**ENVIRONMENTAL ASSESSMENT AMENDMENT  
AND DECISION RATIONALE**

**DUFFY CREEK THINNING  
ENVIRONMENTAL ASSESSMENT No. OR080-1999-10**

CONTRACT NO. OR080-TS00-304

EXHIBIT A

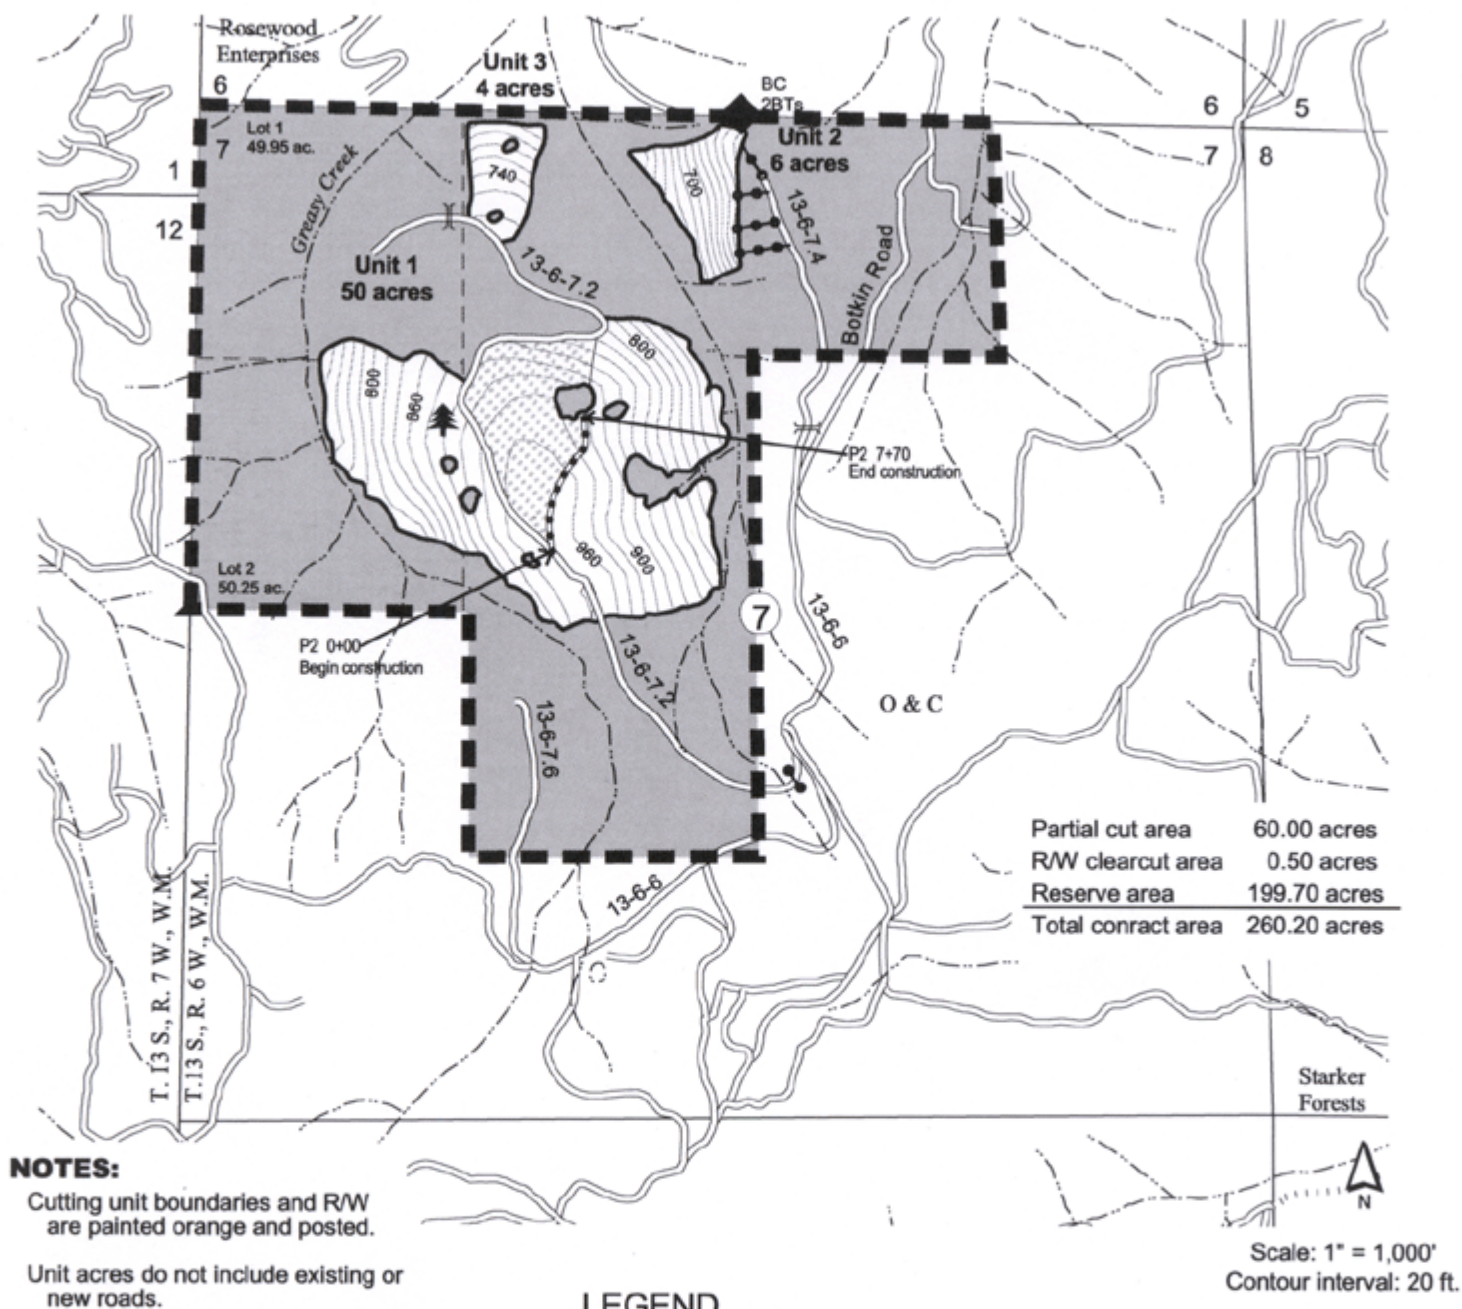
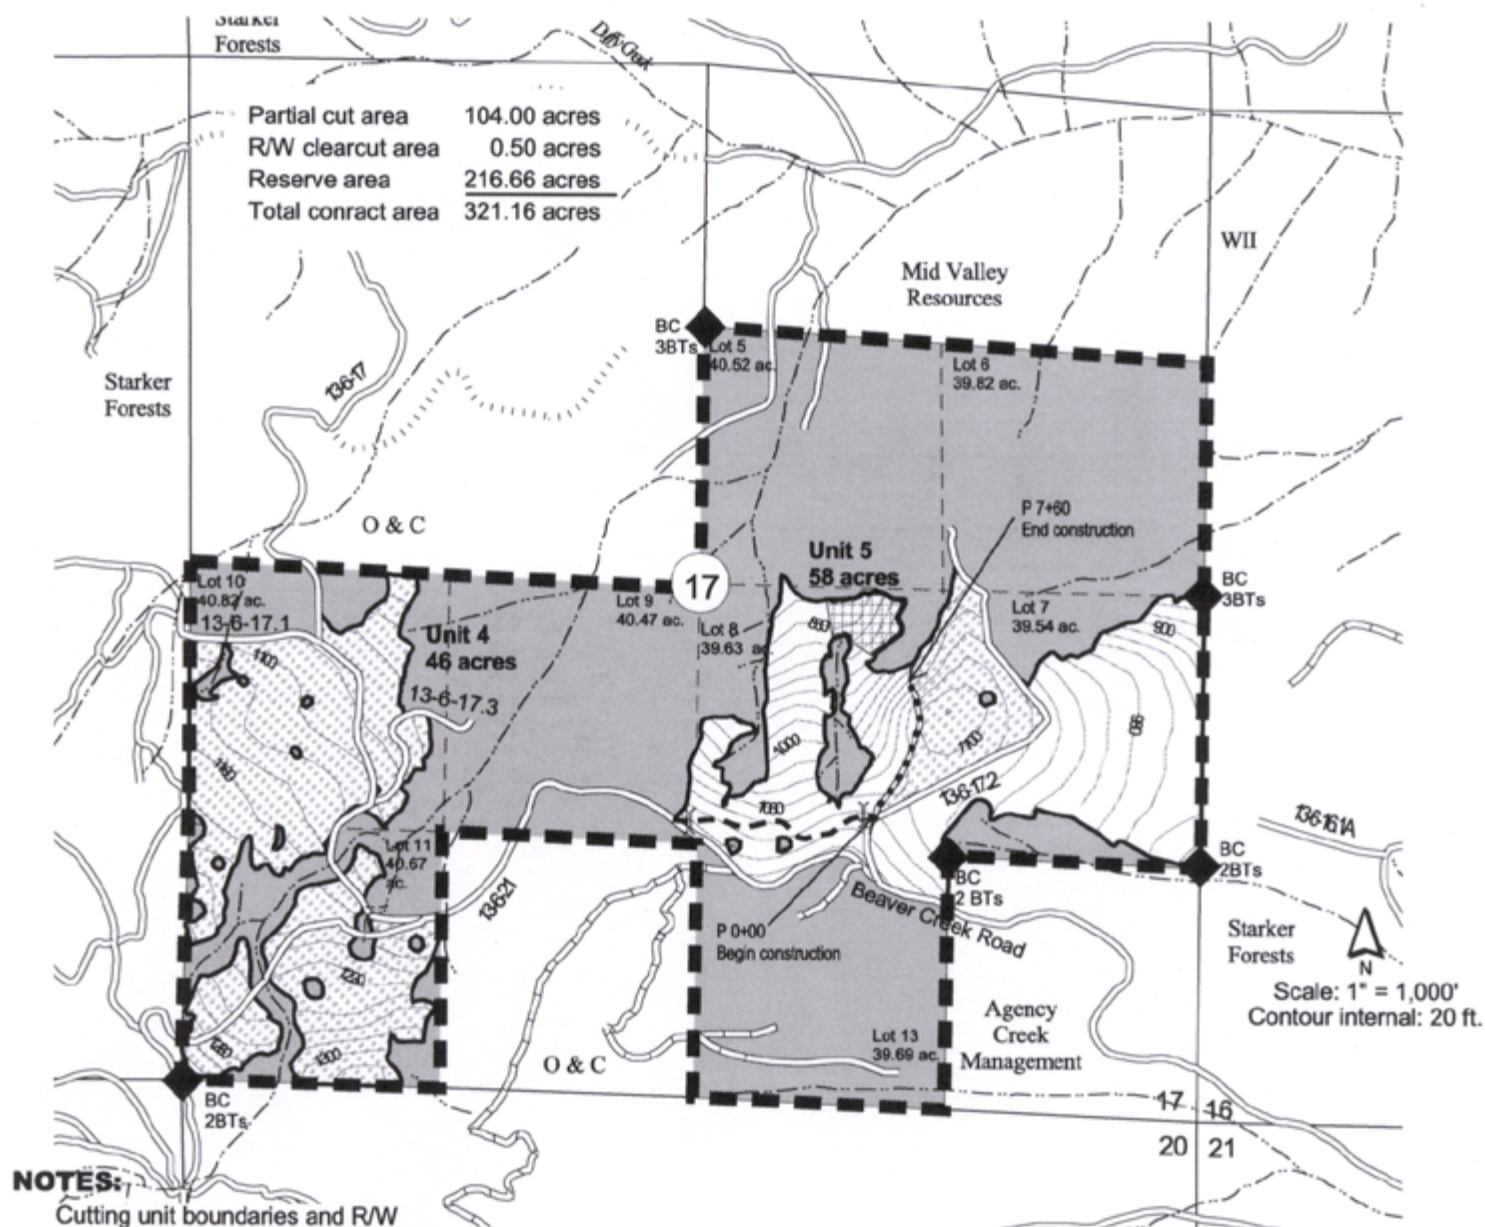
For this change and other changes please refer to the following key to correlate EA unit numbers with the attached Exhibit A map. The key also indicates acreage changes for this implementation.

“Plus” trees are selected, genetically superior trees that are specially valued as a component of the Bureau tree improvement program. After further record search and field verification it was determined that there is only one “plus” tree in the sale area. It would be protected and is located as shown on the attached Exhibit A.
